**Re: Buckley Yard Commercial- Infrastructure Site Plan and Plat**

Thank you for your comments regarding the initial submission for the Buckley Yard Commercial Infrastructure Site Plan and Plat. The following are staff comments dated May 13, 2021 from the city staff and community members. Olsson responses are in **RED** text.

**Initial Submission Review**

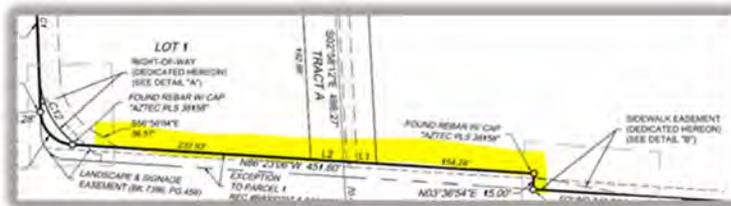
13CC. Since these Lots and Block are divided by a public R.O.W. (Quintero Way), then these Lots and Block will need a new numbering status.

**Lots and blocks have been renumbered.**

**HISTORIC CONDITIONS MAP**  
 BUCKLEY YARD  
 JOB NO. 16044.00  
 02/05/21  
 SHEET 1 OF 1

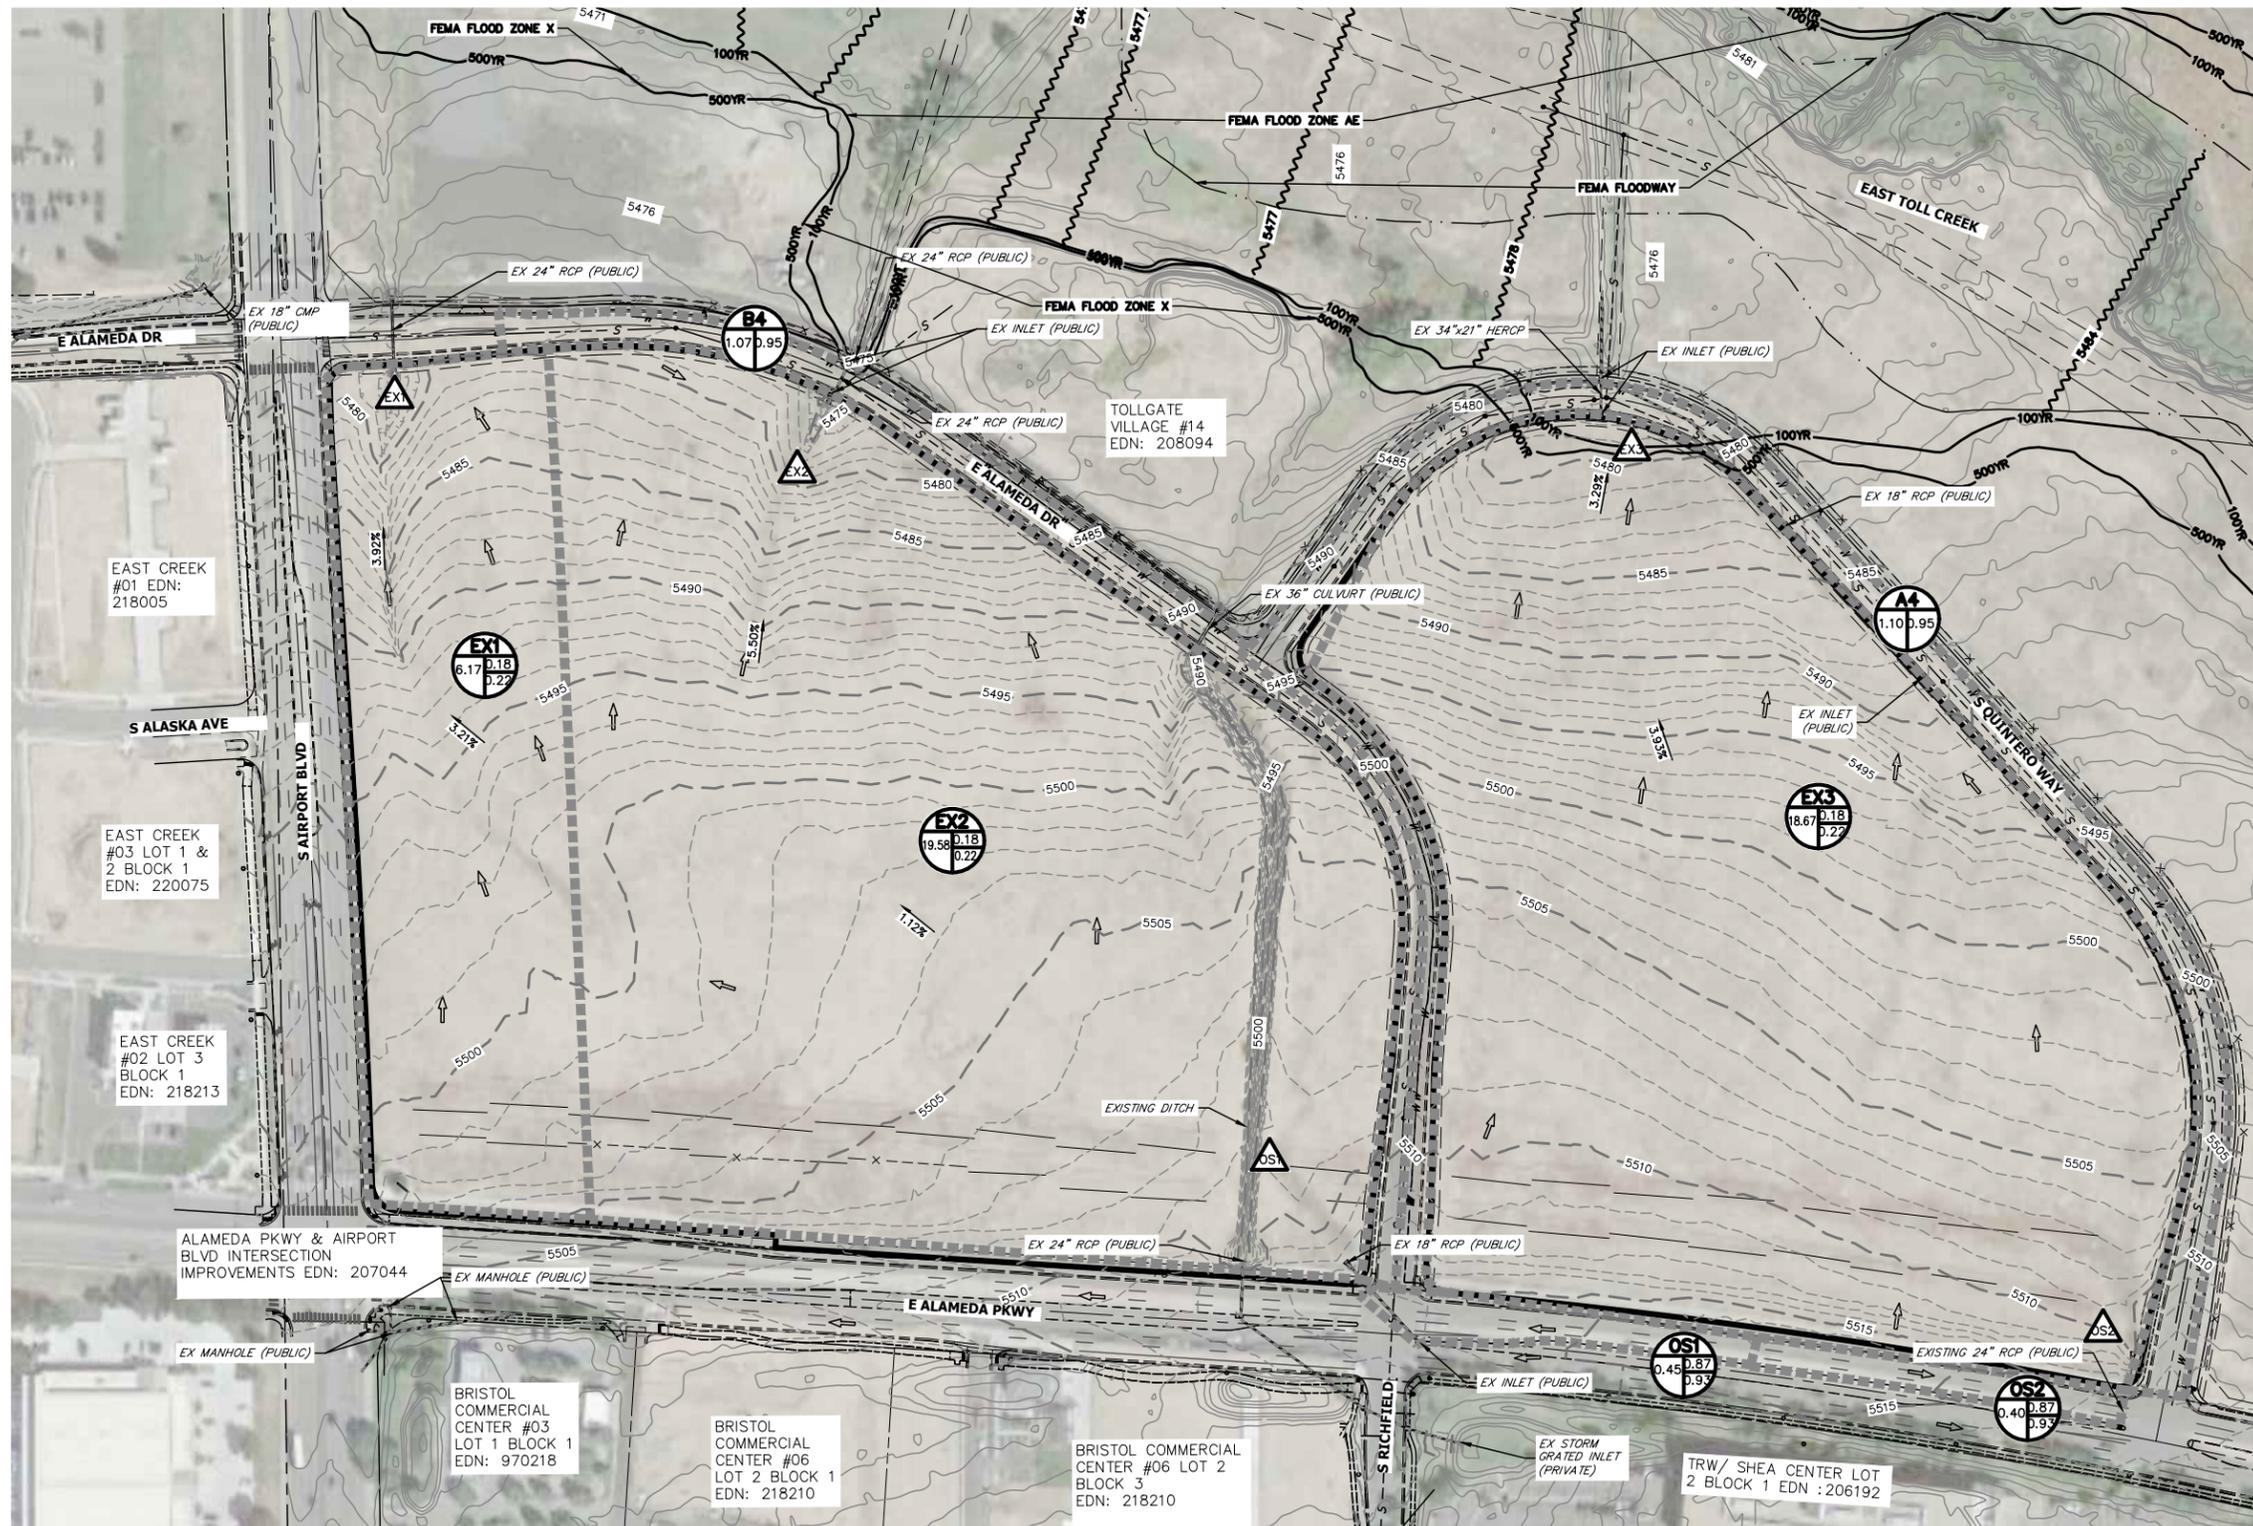
Include the approved version of this map, as well as the approved cover sheet of this Master Drainage Report.
